TITLE: SKETCH PLAN

Thank you for the opportunity to review the **First (1st) Plan Review Submittal (a SWM Concept Plan)** prepared and submitted by **Design Engineering, Inc. on March 6, 2025** for the proposed **Sonina Properties Apartment Improvement (SHA Project No. 25APMO021XX)** on **MD 193** (University Blvd - Mile Point **6.52**) in **Montgomery County**, Maryland.

DATE: 11-Apr-25
TO: Pritam Arora - parora@deius.com
Design Engineering Inc
FROM: Marie LaBaw
RE: Sonina Properties Apartments
320250010

RE: Sketch Plan No. 320250010
Sonina Properties Apartments

DATE:	12/20/24	TITLE:	FIRE TRUCKS ACCESS SITE PLAN			
SCALE:	1"=20'	DRAWN:	EMB			
SHEET:	SK-13	DESIGNED:	PLA/EMB			
	(13 OF 19)	CHECKED:	PLA			
			DATE		REVISIONS	
			03/21/25		Revised	
			DATE		REVISIONS	
					DESCRIPTION	
					DATE	
					DESCRIPTION	
					DATE	
					REVISIONS	
					DESCRIPTION

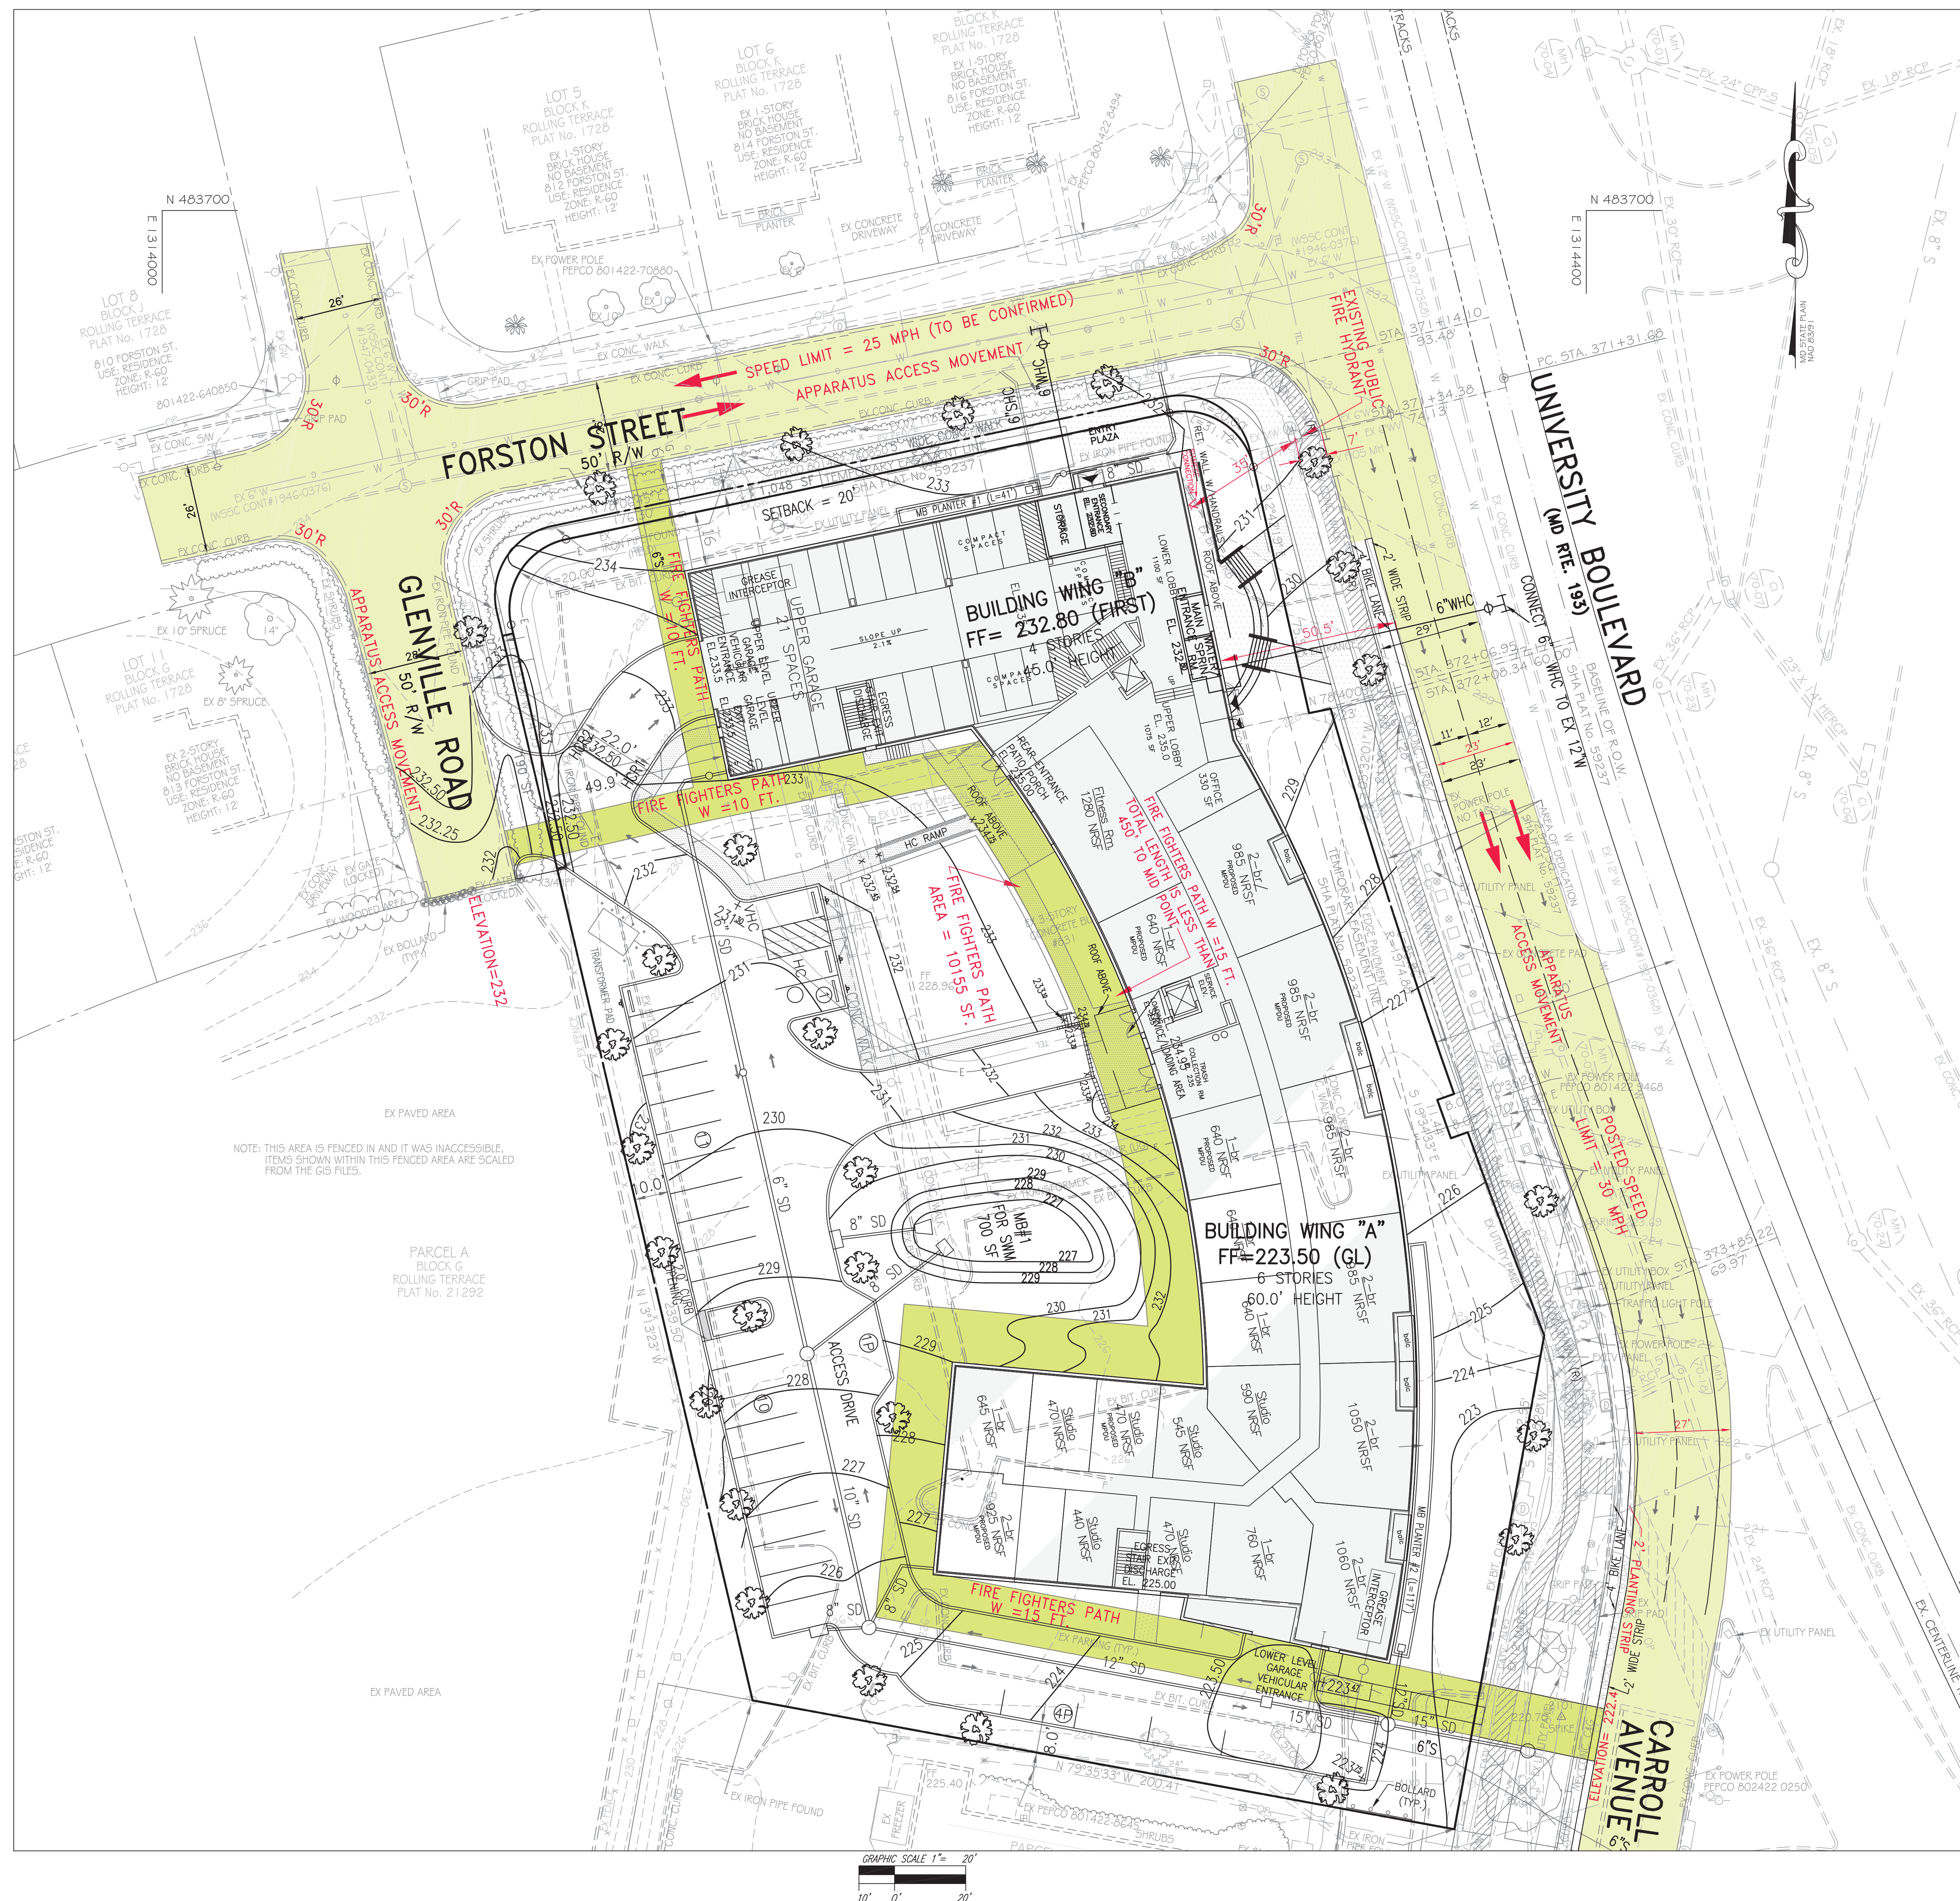
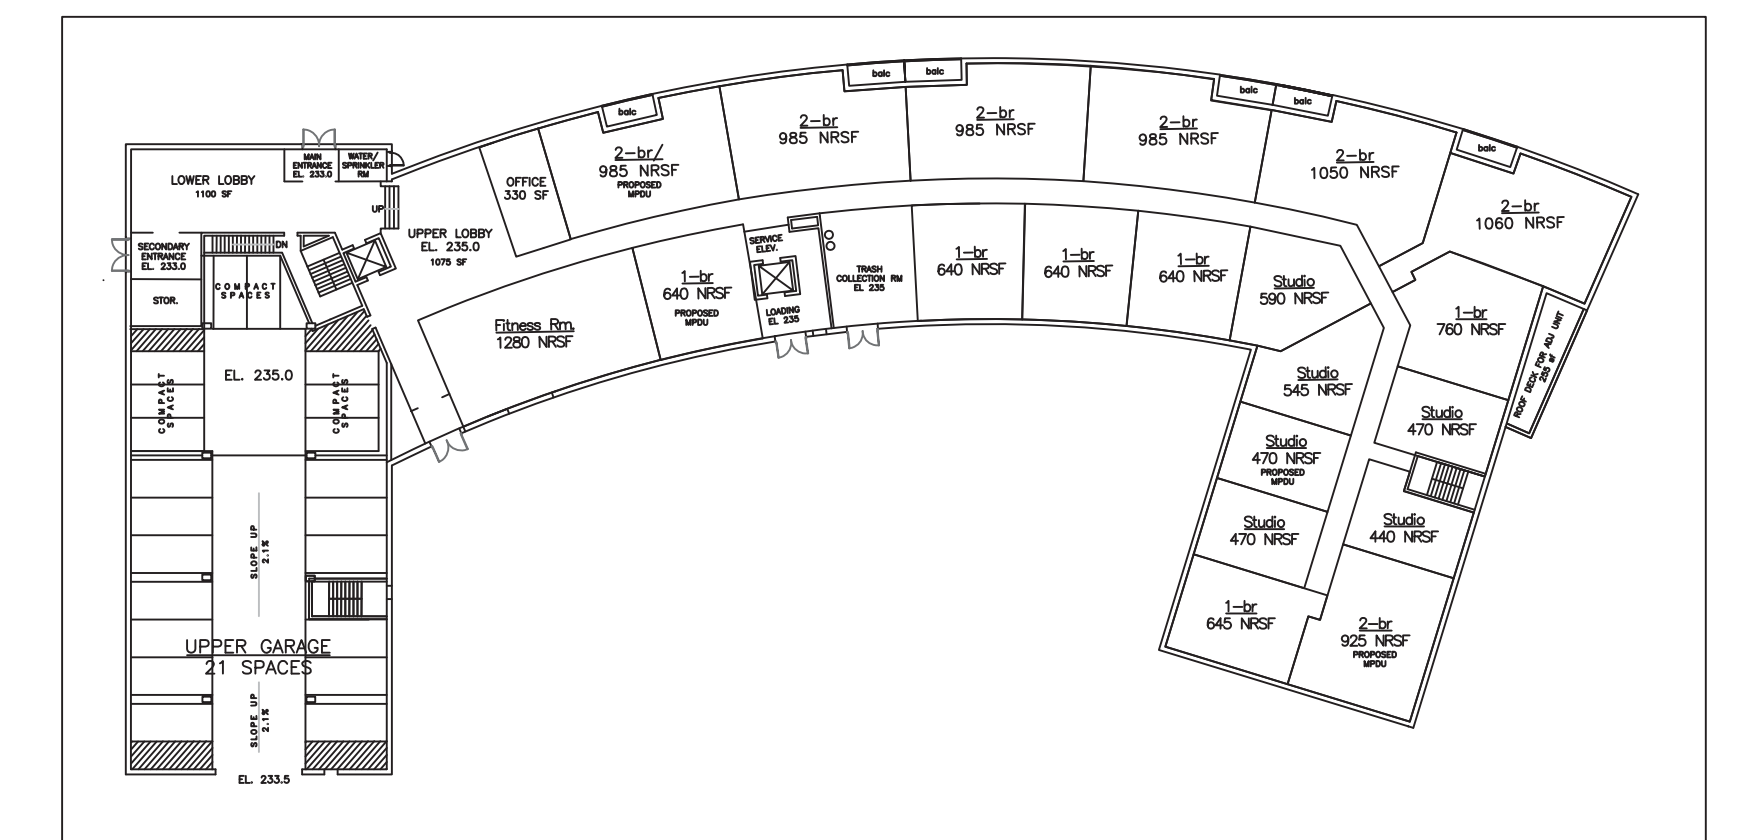
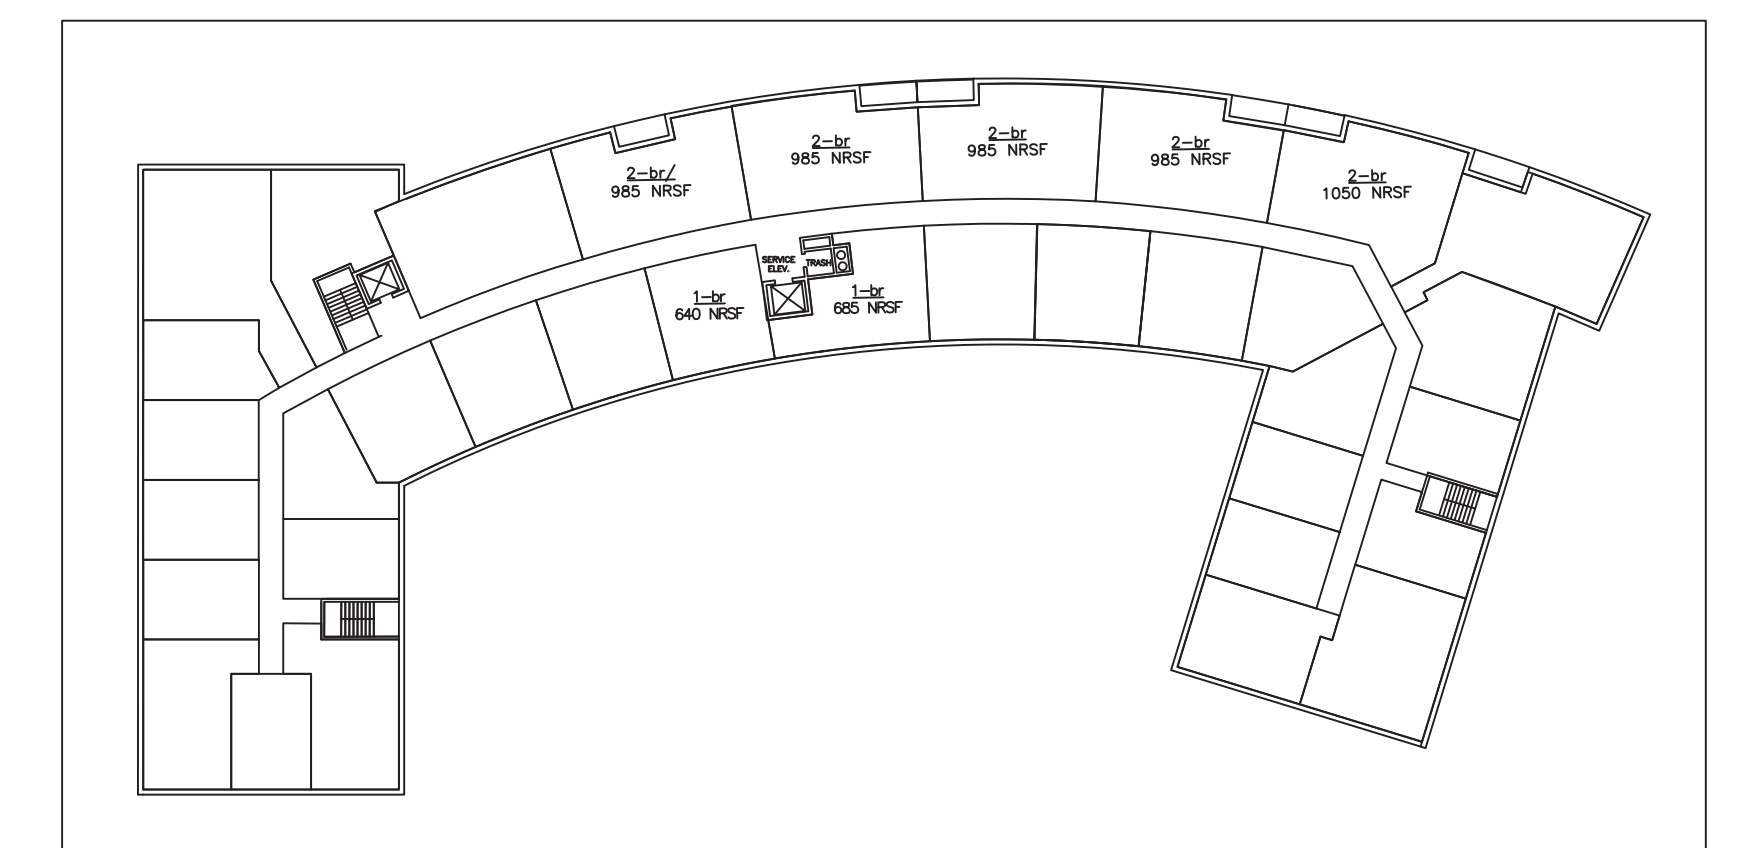
***** MCDOT to coordinate bike lane protections at hydrant with MCDPS Fire Department
Access & Water Supply *****
